Reporting that there will not be sufficient ground left to build the General Hospital Head Stewards & Hospital Assistants quarters at the site proposed.

Submitting rough plans
& sections of the quarters for
the Medical subordinates
attached to the General
Hospital, arranged on the
site opposite the General
Hospital

Quarters for the Medical Subordinates
attached to the General Hospital.

PLAN SHEWING
ON THE NORTH

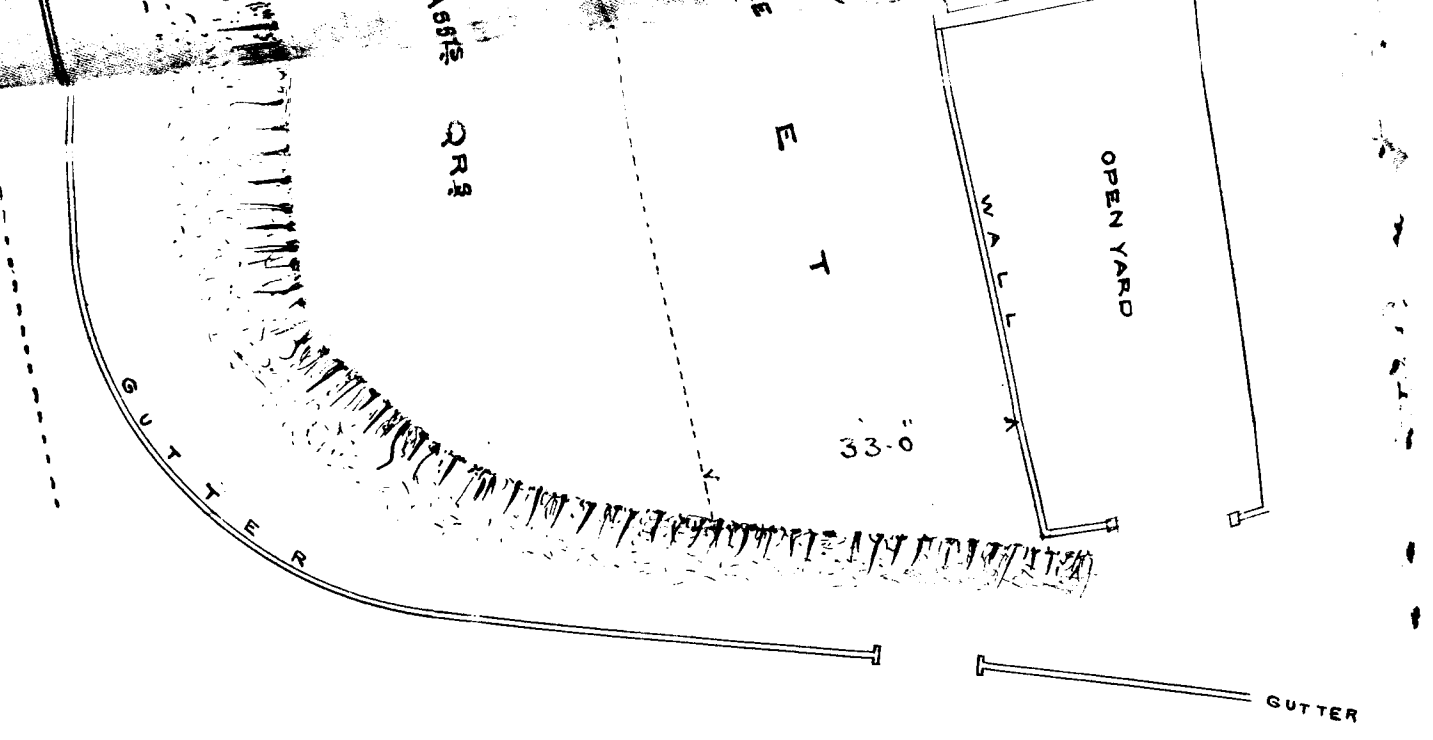
With reference to paragraph 4
of G.O. No. 528 Public dated 26 June 1895 commu-
nicated with G.O. No. 1796 dated 19 July 1895,
I have the honor to report that I communicated
with the President of the Madras Municipal
Commission and that officer states that there
should be a street 33 feet wide between the
existing houses and the proposed quarters &
that under section 244 of the Municipal
act the street should be properly laid out
by the owner of the land. Under these
circumstances it will be seen from the
accompanying plan that there will not
be sufficient ground left to build the
General Hospital near St. Andrews & Hospital
Assistant.

2. The Consulting Architect reports that the President of the Madras Municipal Commission states that there should be a street 33 feet wide between the existing houses and the proposed quarters which should be properly laid.

aid out by the owner of the land. Attention is invited to the plan from which it will be seen that allowing for a street 33 feet broad, there will not be sufficient space left to construct the proposed quarters.

Must remedy shown in the sketch why so wide a street is needed - imagine that hospital against the land & building shown there was no street at all & I don't think one why this narrowness - almost impossible - (if a building it is impossible)

Perhaps the Hon does not know that the existing houses face the road and that it would be most unfair to the owners to erect quarters facing the same way with only a conservancy lane between. Please see Encl. on the current.

With reference to your endorsement, No. 335, dated
24th March 1896, on Current No. 397 of Local and Municipal
Department (herewith returned), I have the honor to inform
you that there is no objection to the street being only
20 feet wide as suggested by the Consulting Architect in
his letter No. 141 dated 11th April 1896, a copy of which is
herewith forwarded.

With ref to the remarks
in para 6 of G.O. 4068 Pub.
of 1.7.96 the Surgeon General
is informed that the
Municipal Commission,
Madras, has replied to
the effect that there is no
objection to the
roadway
being only
twenty feet wide. The Govt
now awaits the complete scheme
called for in G.O. 528 Pub.
of 26.6.95 which should be
expedited.
